Agenda
Board of Adjustment Meeting
Thursday, January 21, 2016
City Hall Council Chamber | 505 Swift Boulevard

BOARD OF ADJUSTMENT AGENDA ITEM COVERSHEET

Applicant: Jeanie Ritchie-Blaski (BA2015-102)

Request: Variance from RMC 23.38.040 to Allow for Construction of a Carport Within One Foot of a Side Yard Property Line

specific carport dimensions
 335.00

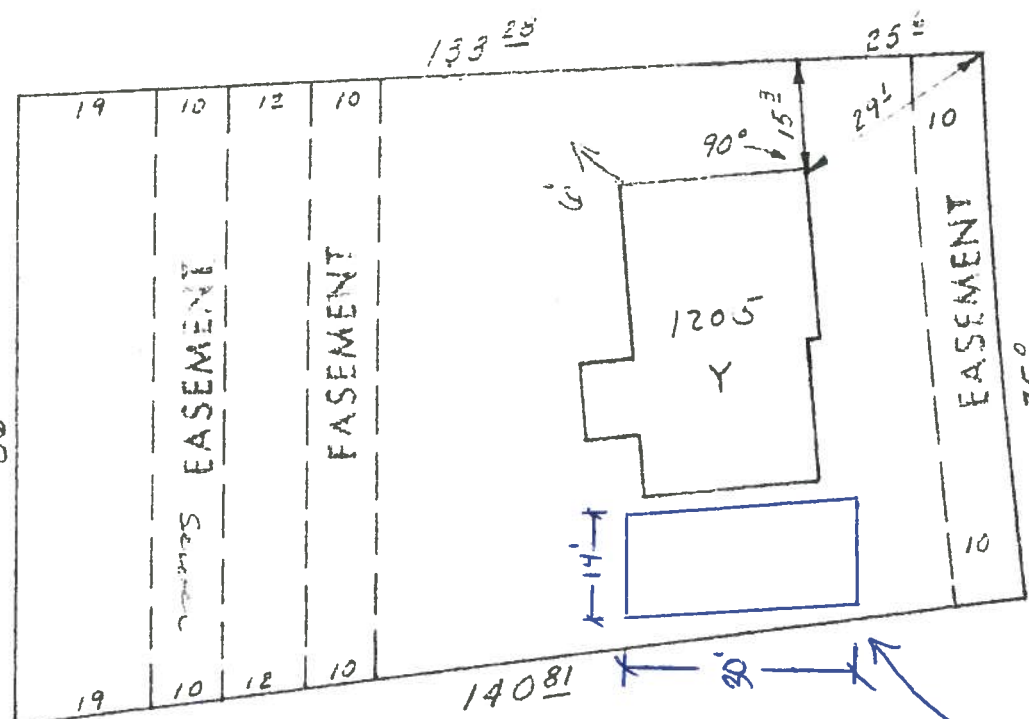
The proposed placement of the carport is the only logical and feasible location for a carport on this particular lot. The only question concerning the carport is really one of its size. Would a smaller carport be sufficient to serve the needs of the residents, rather than the 30 foot by 14 foot structure proposed? This proposed carport, while deeper than normal, is still only 420 square feet in area, which is less than the size of a standard two car garage, which is a common accessory use in the R1-10 zoning district.

In order to ensure that the impacts of the carport within one foot of the property line are adequately addressed, the carport should be designed so that rain water does not runoff onto the adjacent property. With that caveat, staff maintains this proposal would not be injurious to the surrounding neighborhood or detrimental to the public welfare.

1. The carport shall include rain gutters to catch runoff and direct it away from the adjoining lot.
